P5026A-03A-S

Safety Service Note

P5026A Keysight Streamline USB Vector Network Analyzer

“POTENTIAL BURN INJURY (HIGH TEMPERATURE) HAZARD”

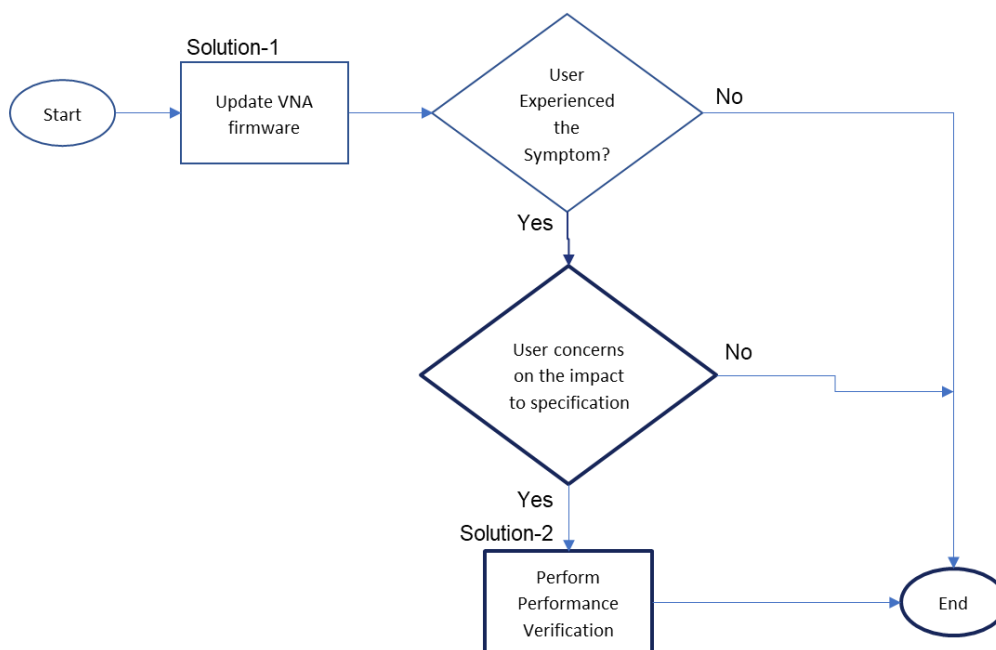
VNA fails to start with the following symptoms.

1. LED indicator (below circle) turns red.
2. cooling fan does not work
3. If user leaves the VNA with this LED indicator red without turning off power switch, it continues to overheat and becomes too hot.

Solution-1: Update VNA firmware by user

Solution-2: Perform Performance Verification by Keysight

1. **Install the latest VNA firmware Rev. A.15.55.14 or newer** on users' controller PC(s).
The latest firmware enhanced the thermal fan control mechanism.
2. Once the latest firmware is installed, proceed with the restart of both **controller PC** and **VNA**.
3. Launch the VNA firmware. Ensure VNA powers up and launches into firmware correctly after firmware update is done.
